STERLING RANCH ROAD & BRIARGATE PARKWAY STORM PLANS

STORM SEWER PLANS

PCF FILING NO.: CDR 221

v4_CDs Storm.pdf Markup Summary

**DP12 PROFILE(4)
STA 30+50.00 TO 37+50.00**

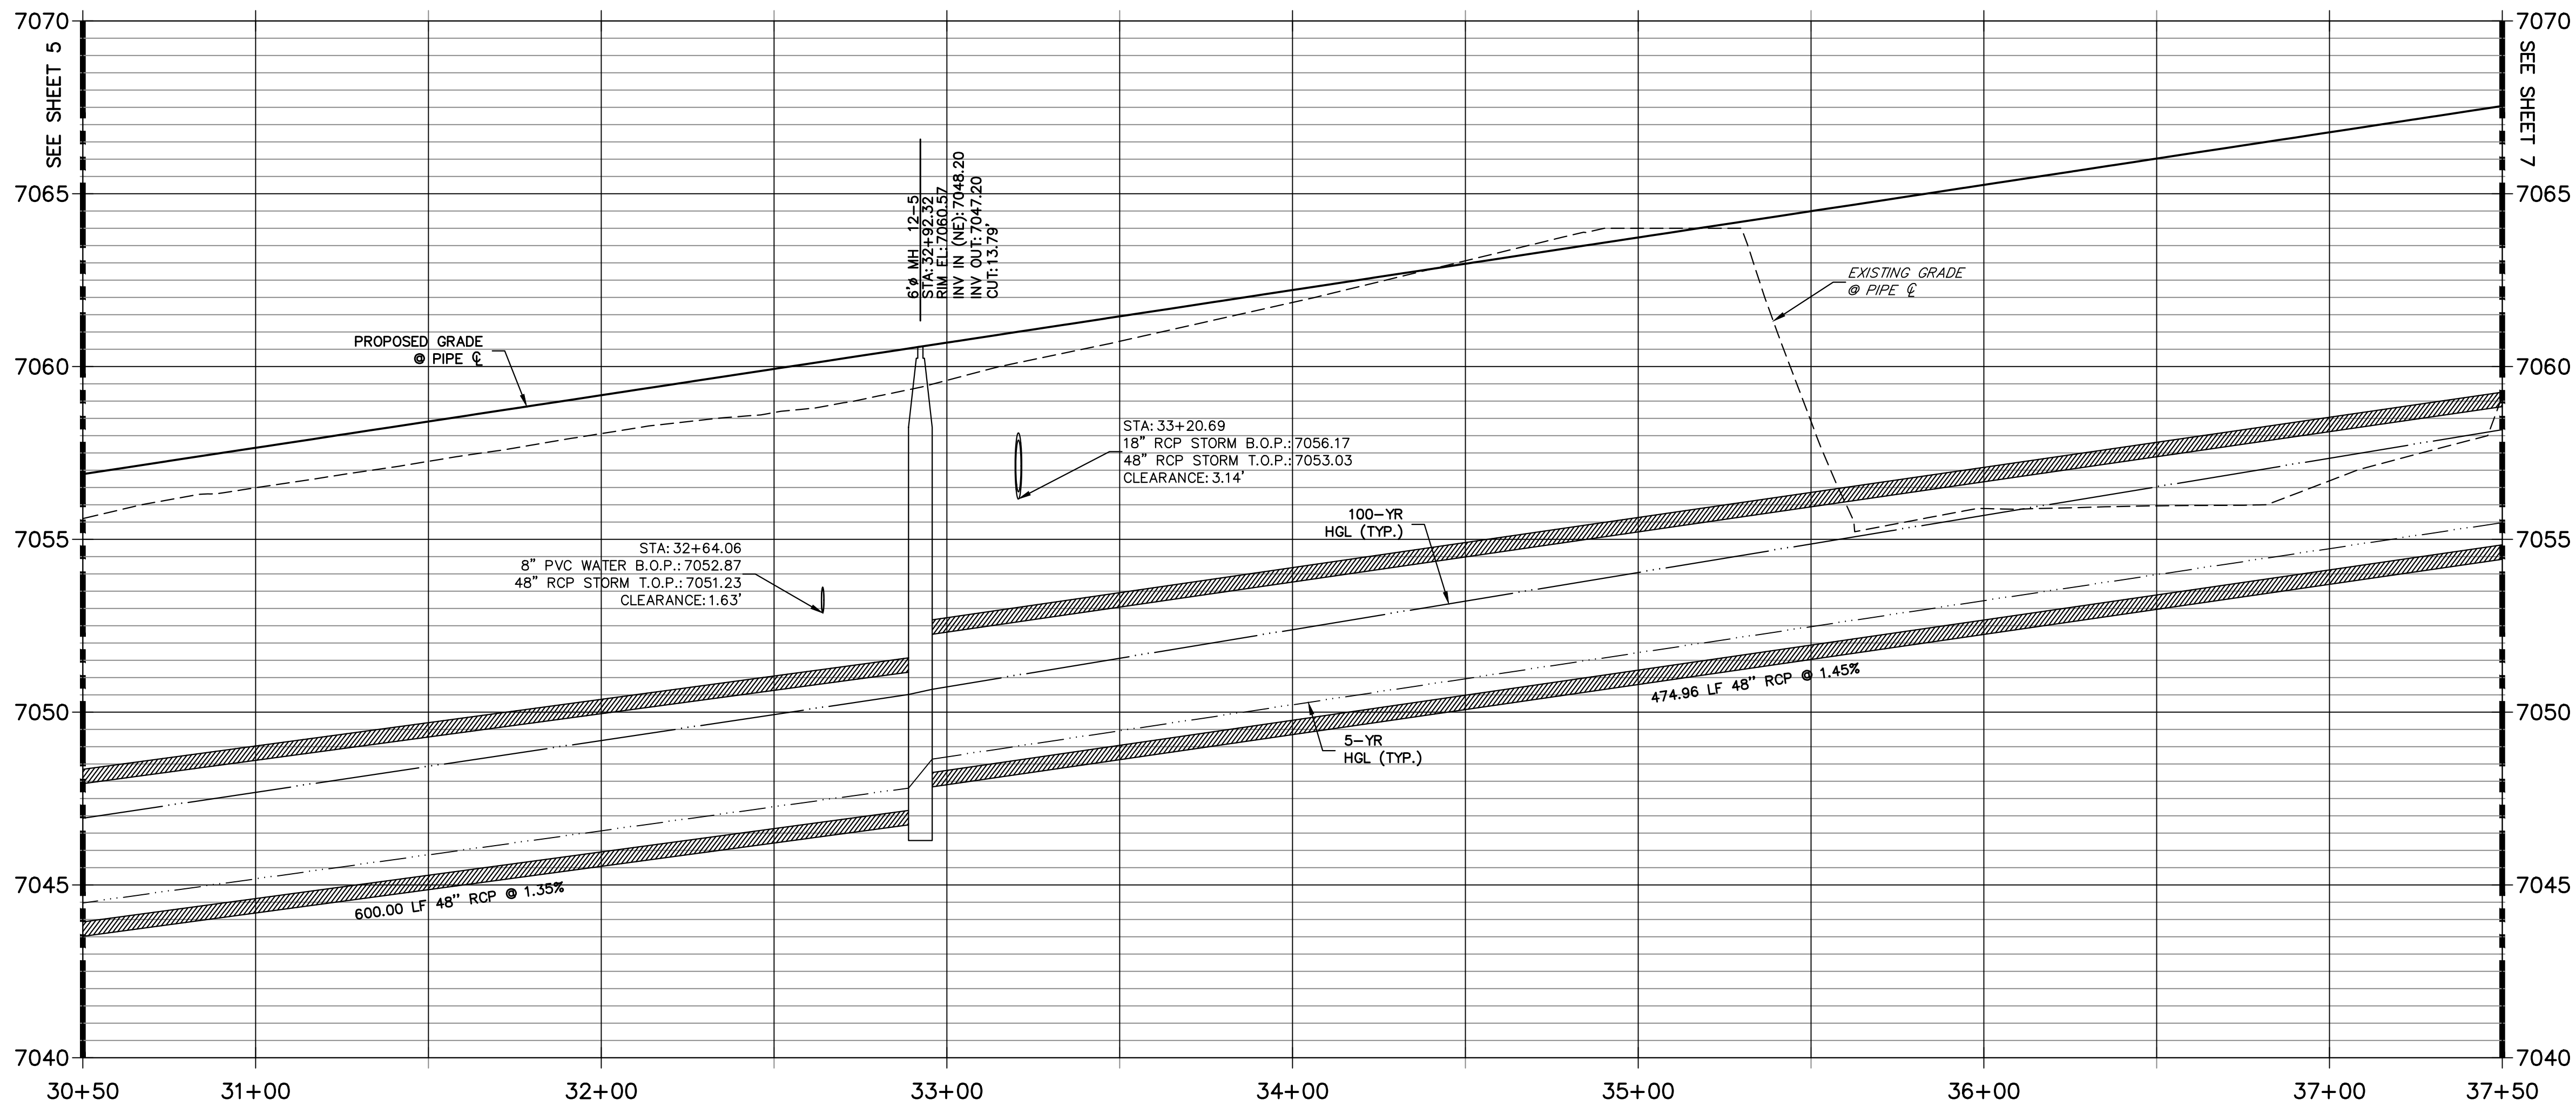
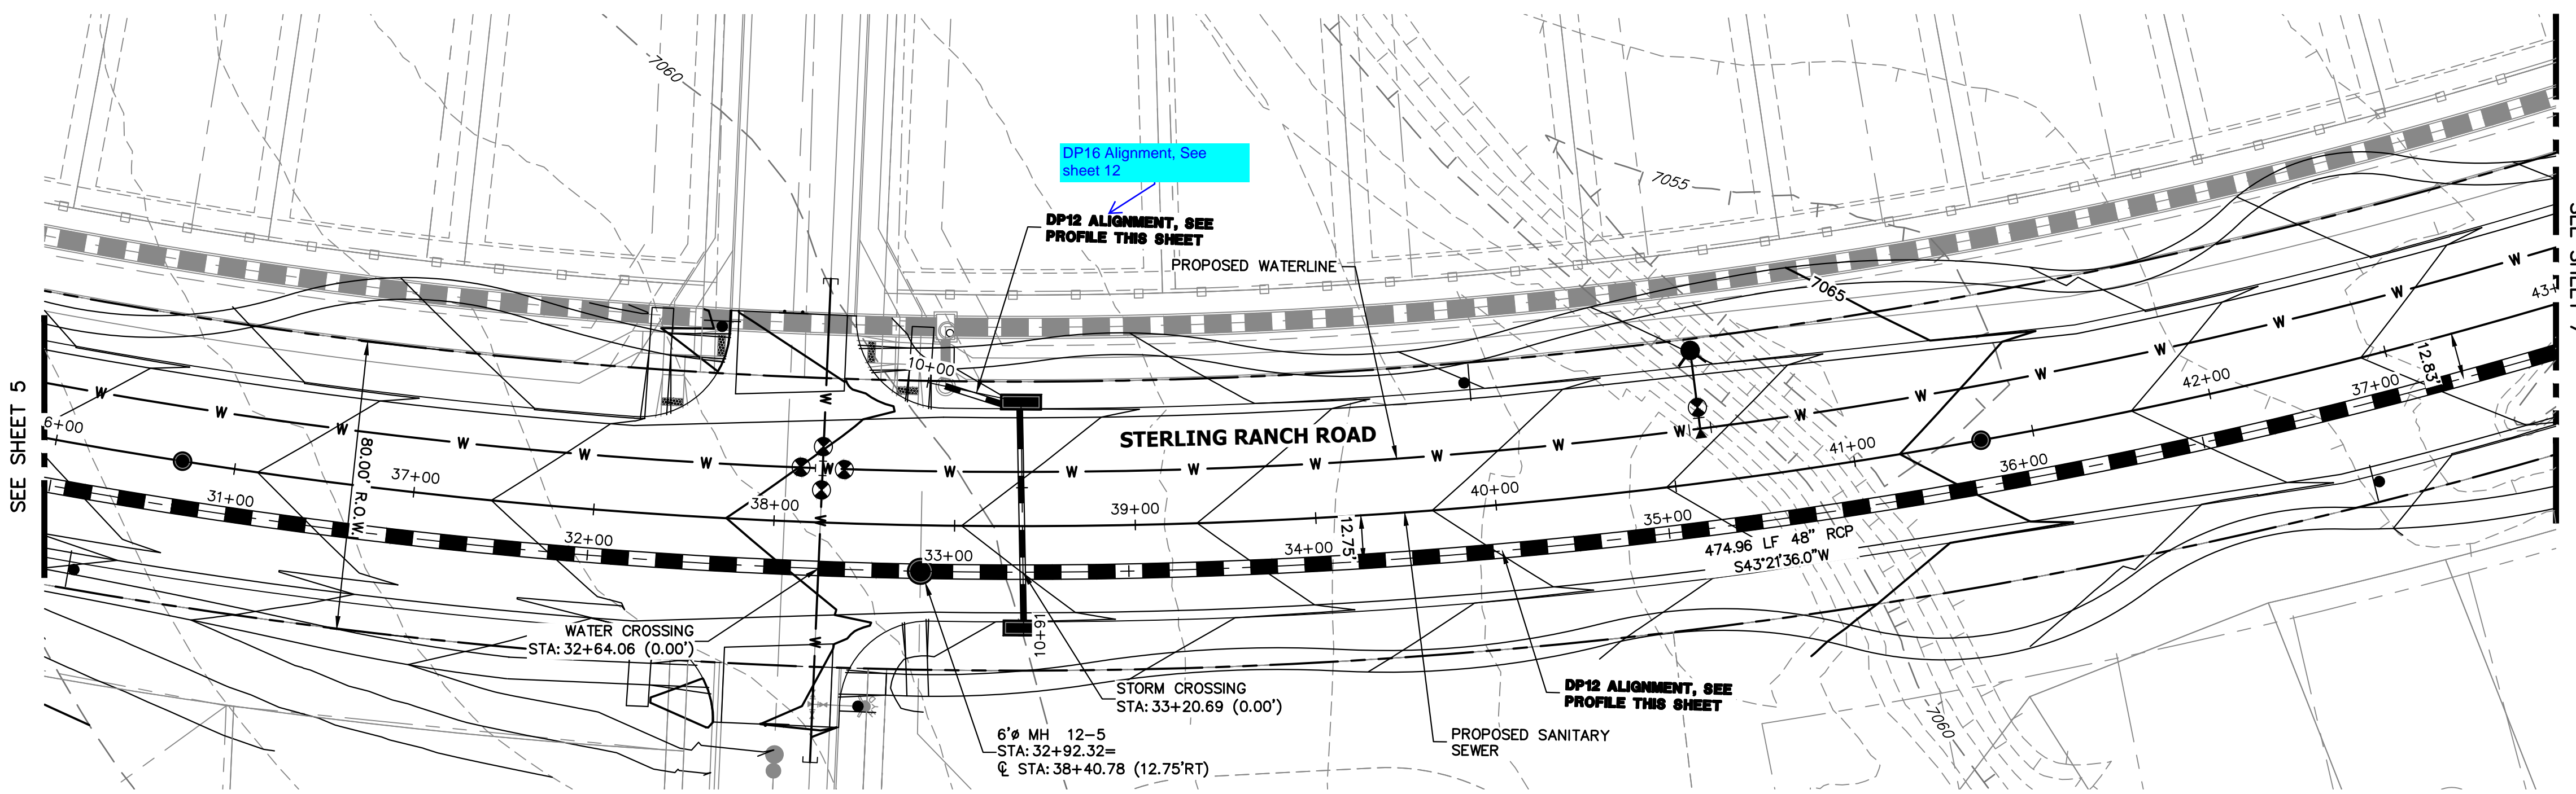
DP16 Alignment, See sheet 12

**DP12 PROFILE(7)
STA 50+00.00 TO 56+00.00
PUBLIC**

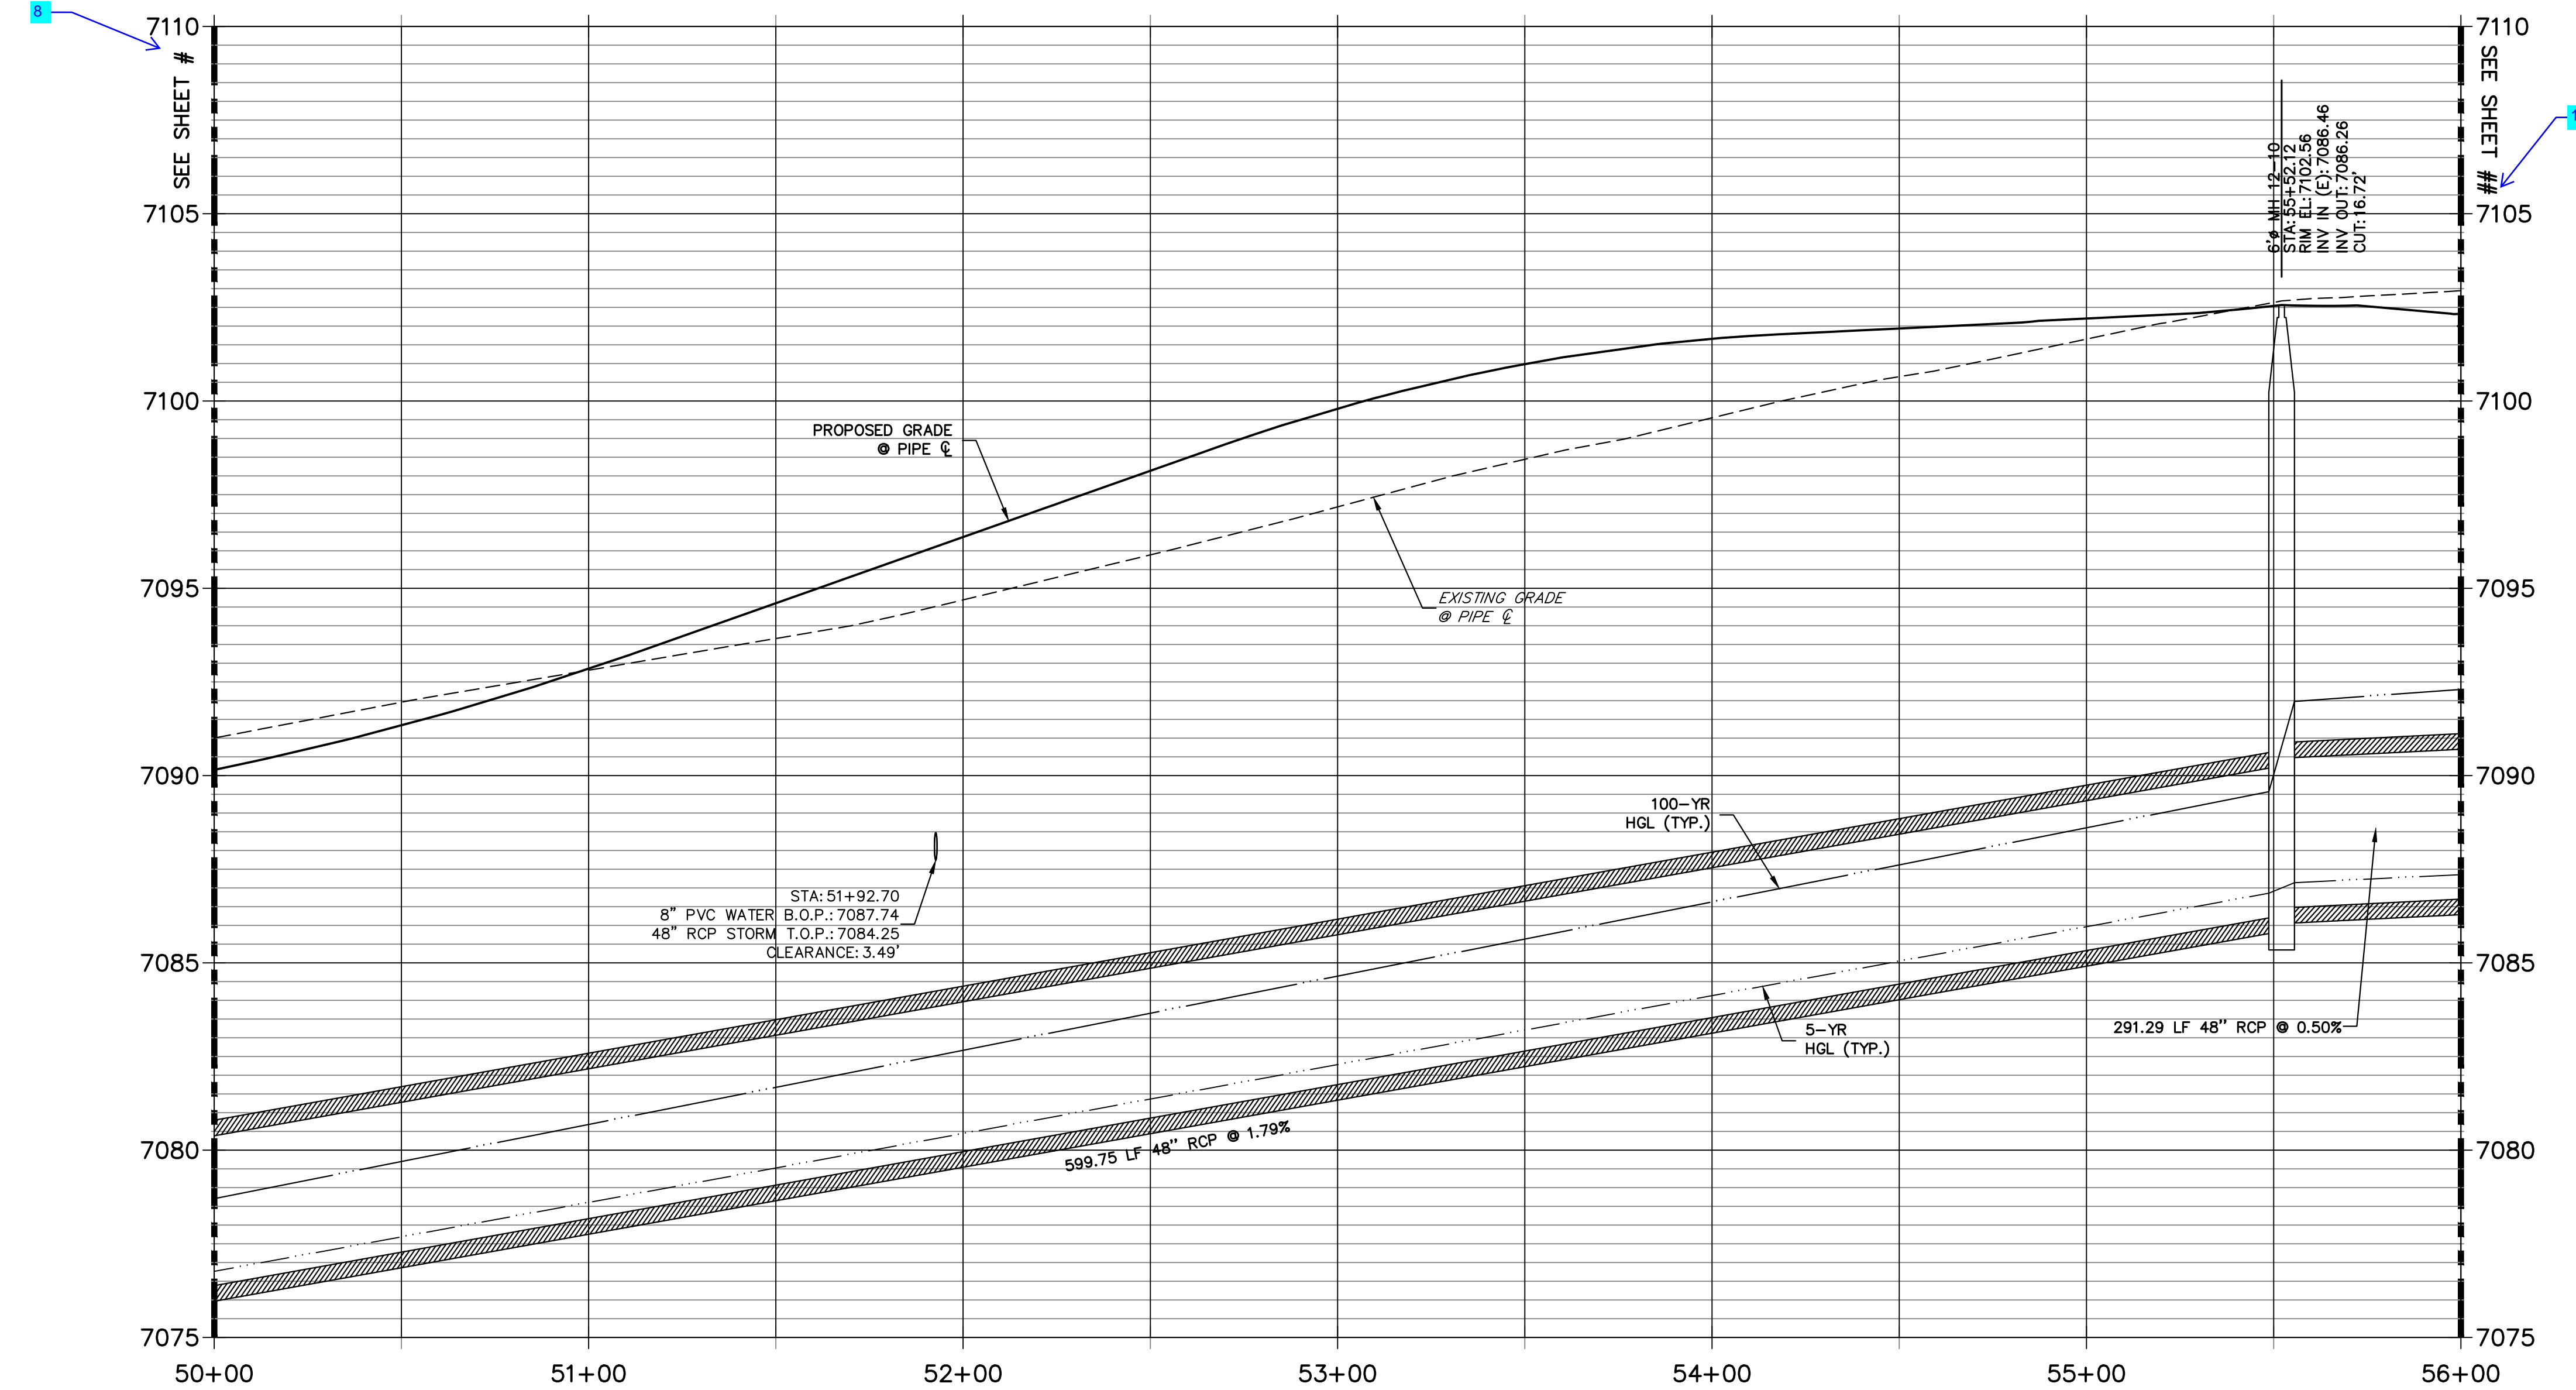
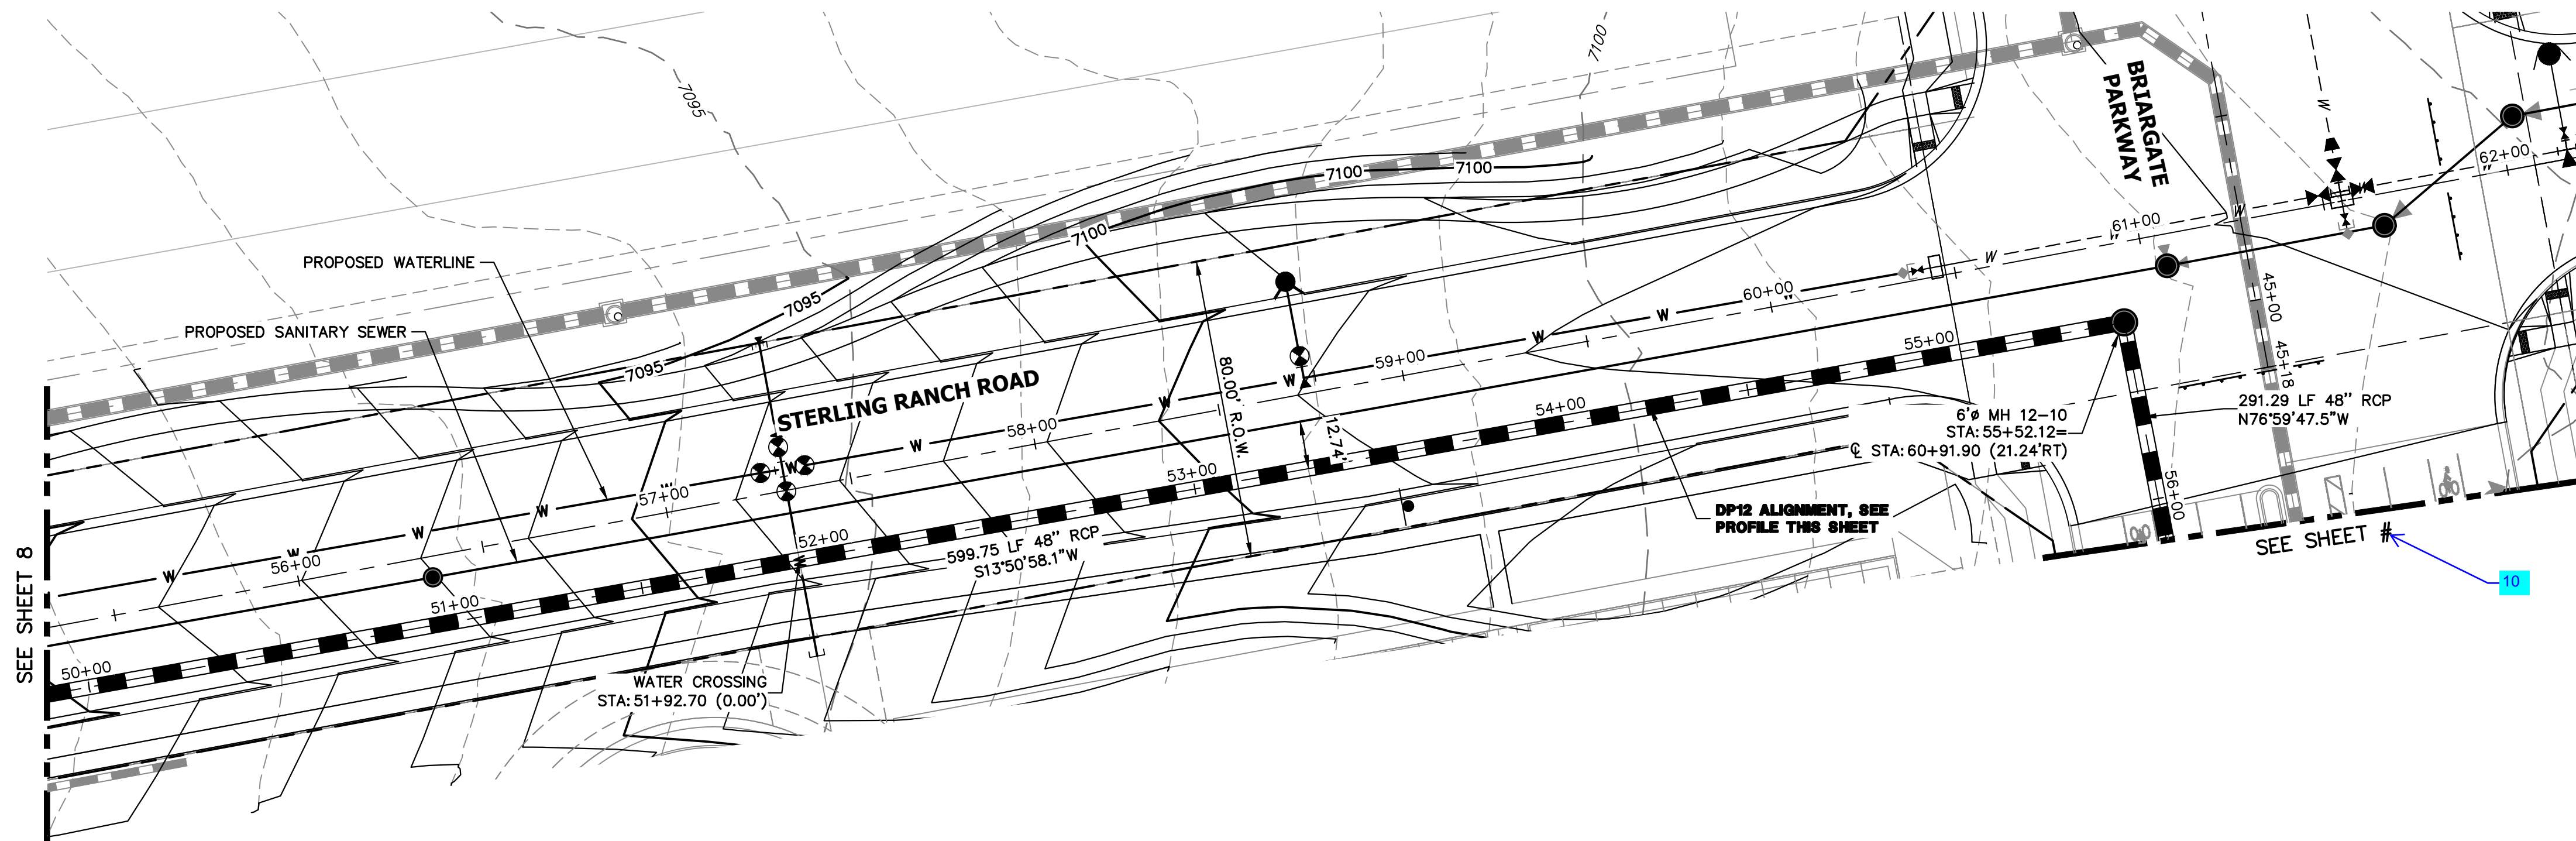
8

10

10
